Access Compliance Report

Public Rights-of-Way

(Curb Ramps)

Intersection ID: 11181	Main Street: ALANBROOK_RD	Cross Street: TRAVERS_RUN_DR	Location: W
ADA ID: 4A1CDF7C41C3	Ramp Type: BlendTrans1	Initial Pass/Fail: Fail	Overall Compliance: No
Severity Score: 10			
Codes/Mitigation Info/Possible Solution		Field Measurements/Component Compliance

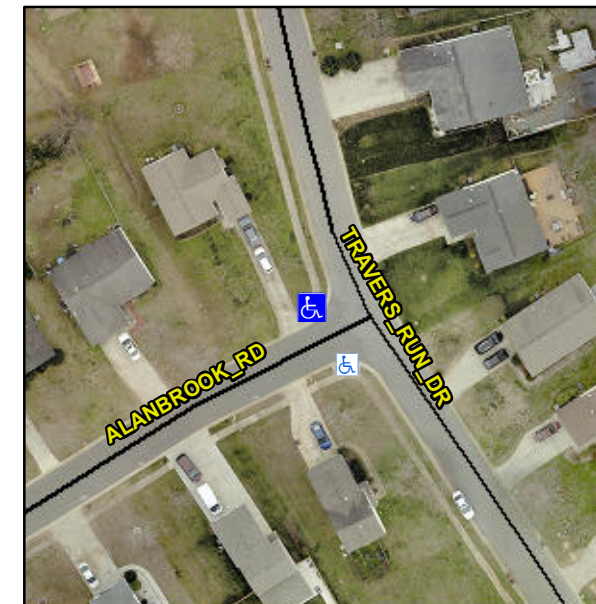
Not Found, R304.5.1, R304.5.3

Compliance	Description	Data	Compliance	Description	Data
N/A	Ramp Length (in)	45.0	Yes	BlendTrans Slope (%)	1.2
No	Ramp Width (in)	41.0	No	BlendTrans XSlope (%)	2.4
N/A	Flare Type LT	N/A	N/A	Flare Type RT	N/A
N/A	Flare Slope LT (%)	N/A	N/A	Flare Slope RT (%)	N/A
N/A	Flare Traversable LT?	N/A	N/A	Flare Traversable RT?	N/A
N/A	Landing Length (in)	N/A	N/A	DWS Provided?	N/A
N/A	Landing Width (in)	N/A	N/A	DWS Contrast?	N/A
N/A	Landing Slope (%)	N/A	N/A	DWS Length (in)	N/A
N/A	Landing X Slope (%)	N/A	N/A	DWS Full Width?	N/A
N/A	Landing Curb? (Y/N)	N/A	N/A	DWS Offset (in)	N/A
N/A	Shared Landing?	N/A			
N/A	Gutter Ponding?	N/A	N/A	Gutter Slope (%)	N/A
N/A	Gutter Lip Ht (in)	N/A	N/A	Gutter X Slope (%)	N/A
N/A	Painted X Walk1?	No	N/A	Painted X Walk2?	N/A
	X Walk 1 Direction	To SE		X Walk 2 Direction	N/A
	X Walk 1 Width (in)	N/A		X Walk 2 Width (in)	N/A
	X Walk 1 Slope (%)	3.2		X Walk 2 Slope (%)	N/A
	X Walk 1 X Slope (%)	1.4		X Walk 2 X Slope (%)	N/A

N/A	Ramp inside XWalk1?	N/A	N/A	Ramp inside XWalk2?	N/A
	Road Slope (%)	1.4		Clear Space?	N/A
	Road X Slope (%)	3.2	N/A	Clear Space to XWalk (in)	N/A
N/A	Any Obstructions?	N/A	N/A	Storm Grate/Utility Hazard?	N/A
	Obstruction Type			Storm Grate/Utility Type	
		N/A			N/A
			Yes	Surface Condition? (G/P)	Good
			No	Curb Slope (%)	12.7

Remove & Replace Curb Ramp With Two New Directional Ramps or Equivalent.
